REMARKS

Drawings

FIG. 1

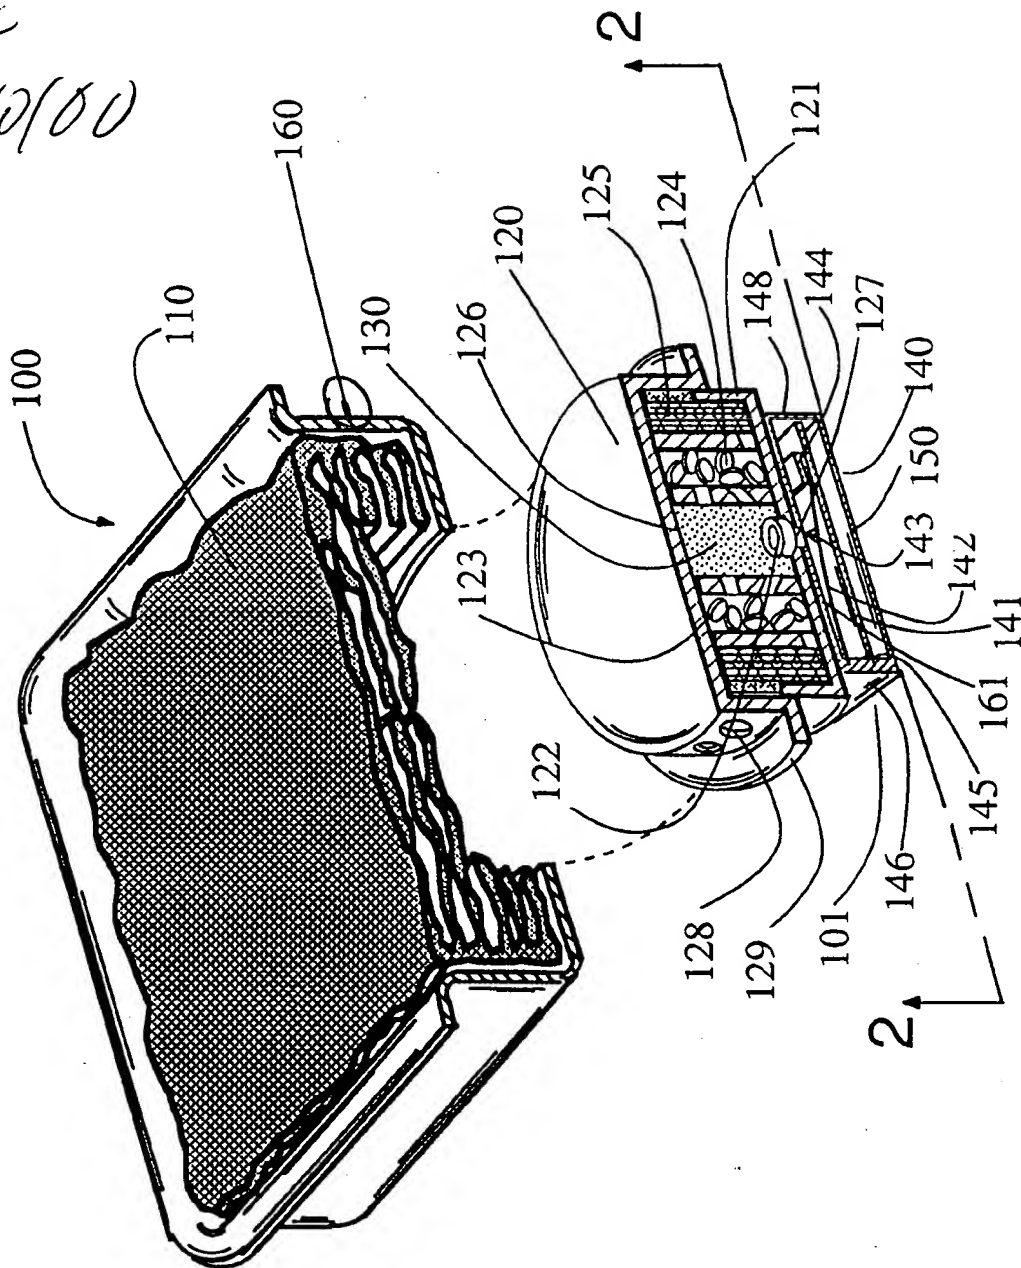
Proposed revised Fig. 1 is submitted herewith in which the lead line for reference numeral 160 touches the plate (the change being marked in red ink).

FIG. 2

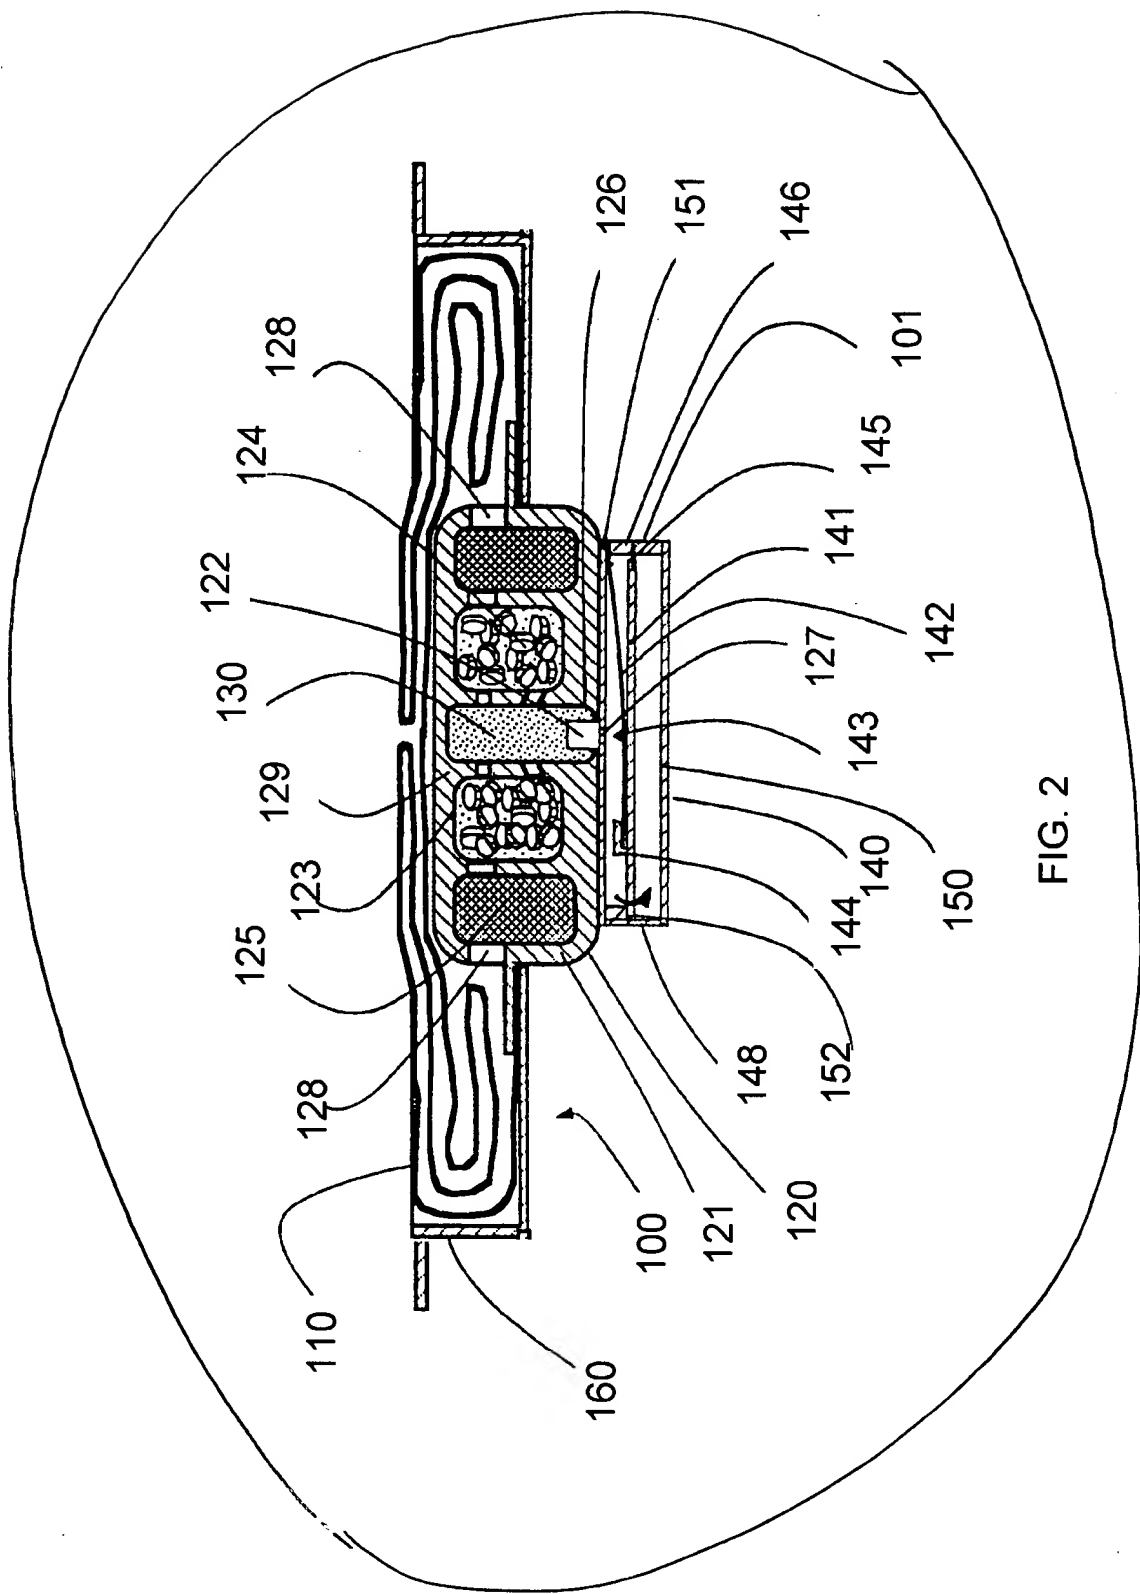
Proposed revised Fig. 2 is submitted herewith in which the designation of the mounting plate has been changed from 130 to 160. Also, the drawing has been inverted to be consistent with Fig. 1. The shape of the plate 160 in Fig. 2 has also been changed to be consistent with the shape of the plate in Fig. 1.

FIG. 12

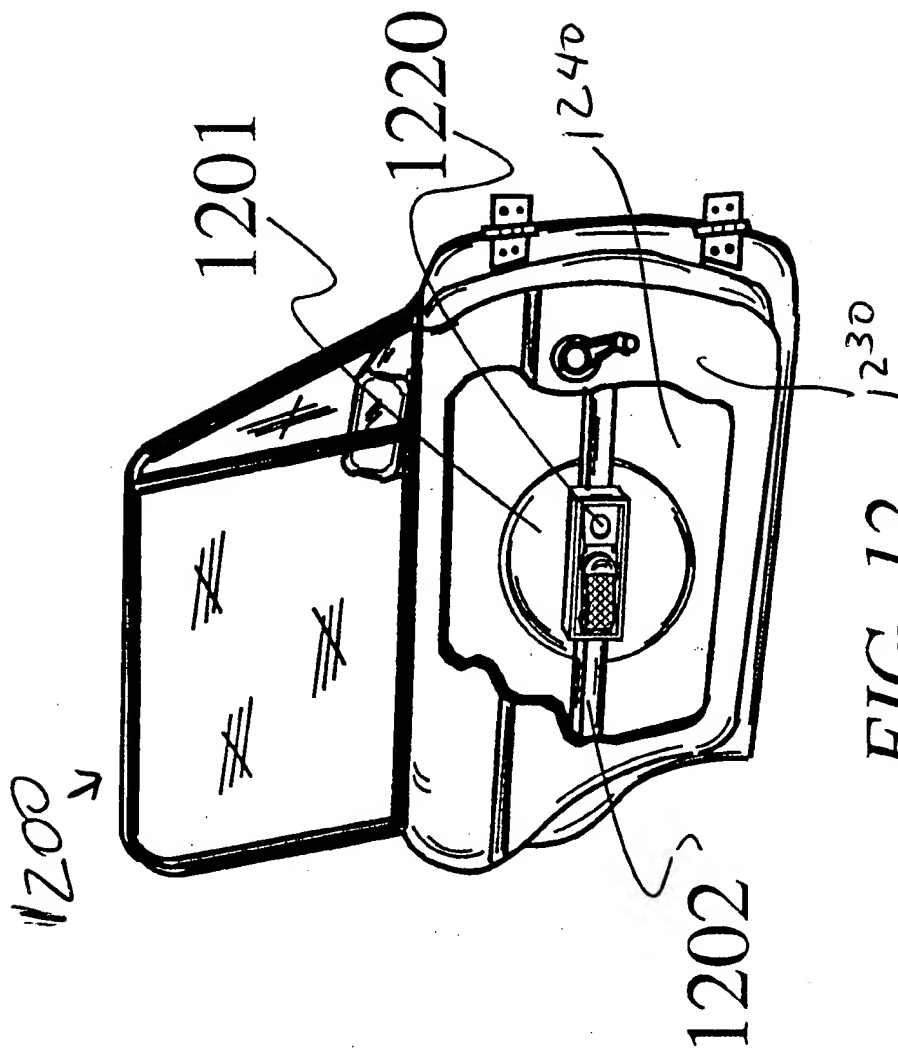
In this regard, it is noted that an embodiment wherein panels are associated with a door is shown in both Fig. 16 (module 1601) and in Fig. 12 (airbag system 1200). The specification has been amended at page 20 to clarify the arrangement of the airbag system 1200 between the inner and outer side panels of the door. Proposed revised Fig. 12 is also submitted herewith with some additional reference numerals.

FIG. 13

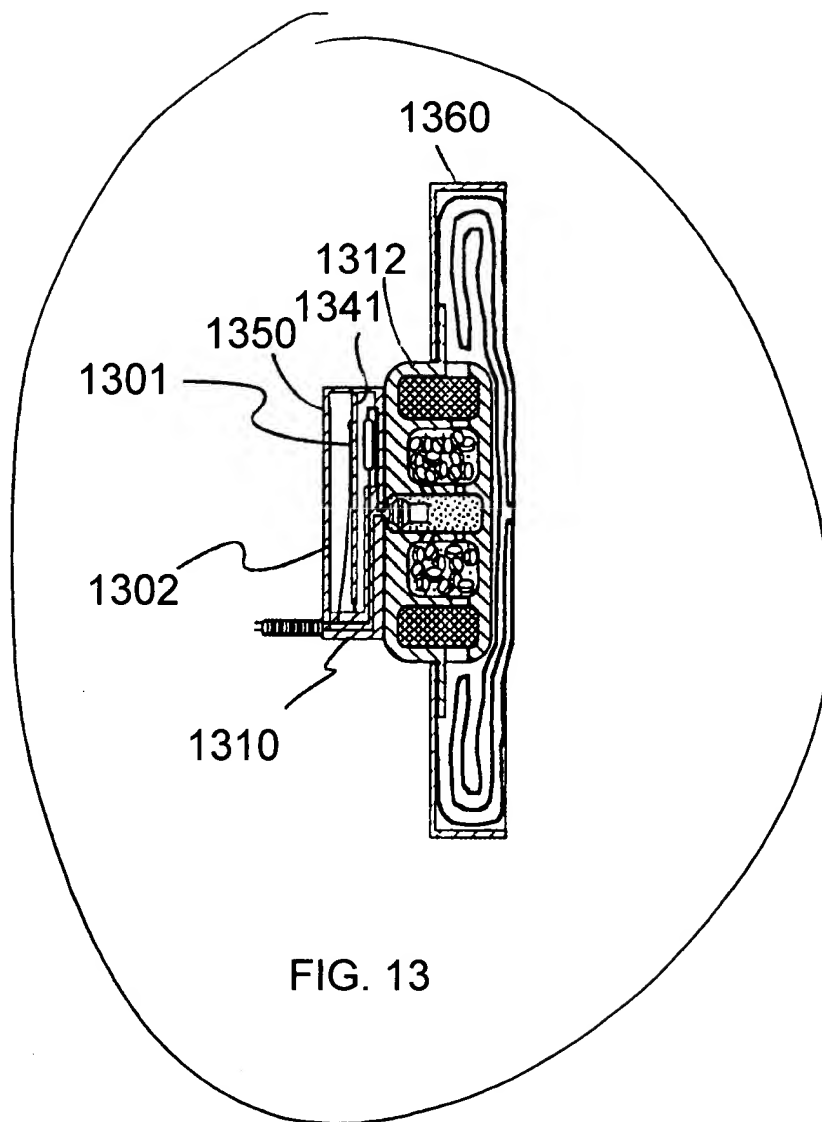
Proposed revised Figs. 13 and 14 are submitted herewith in which the drawings are in the proper orientation, i.e., the airbags face sideward.
